E8267D-13

S E R V I C E N O T E

E8267D PSG Vector Signal Generator

Spurs and poor image rejection in wide band IQ mode (option H16 & 016).

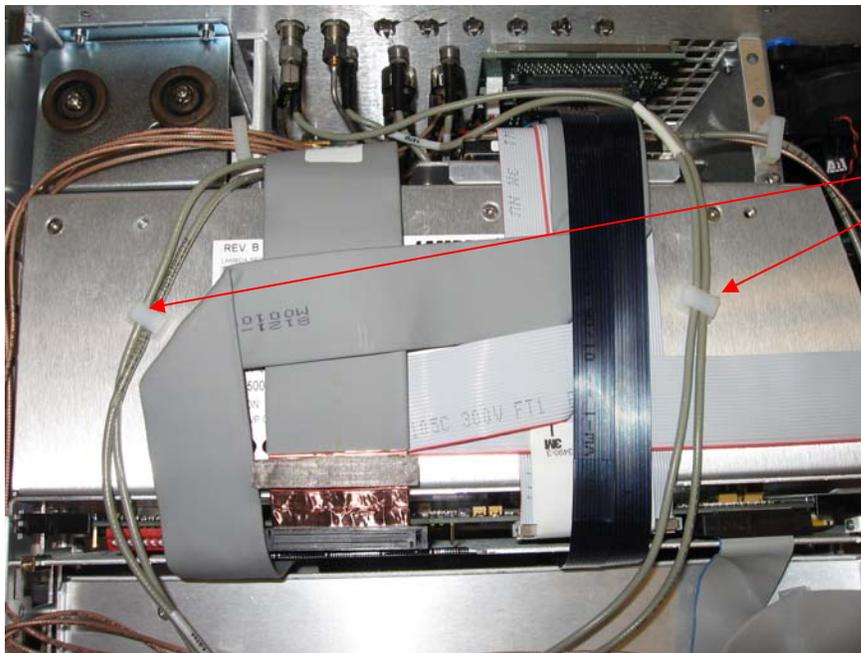
E8267D instruments with option H16 or 016 may have spurs and poor image rejection when wide band IQ mode is being used. The spurs and poor image rejection may be caused by mismatched cables in the wide band IQ path.

Solution/Action:For customers reporting problems with spurs and poor image rejection in wide band IQ mode replace the following cables and install the new bulkhead adapters.

1. Remove the external and internal covers. See service guide for process to remove and reinstall covers.
2. Remove from the rear panel the wide band input cables I, I bar, Q, Q bar (W123-125) from the rear panel and from A13 IQ MUX. Note the routing so the new cables can be routed the same way.
3. Install the 4 SMA bulkhead adapters 1250-1666 into the rear panel in place of the cables.
4. Connect the 4 new 8121-1667 cables to the rear panel adapters, route the cables the same as the old cables were routed and connect the other ends to the A13 IQ MUX according to the following:

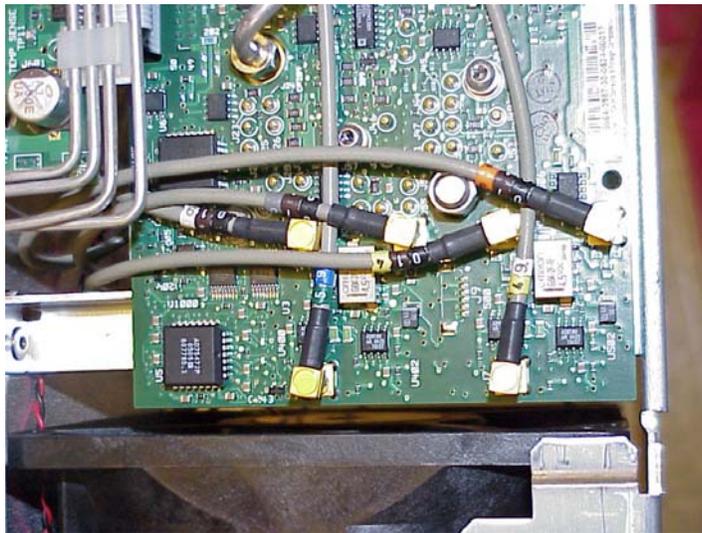
6. Remove the following 4 cables and install the 4 new 8121-1616 cables to the A13 IQ MUX and to the A35 IQ Modulator according to the following table:

7. Make the following adjustments
 - a. RF Timing Skew Calibration
 - b. IQ Cal (Press I/Q, I/Q Calibration, Calibration Type (Full), Execute Cal)
8. Do the following performance tests.
 - a. EVM and IQ Offset
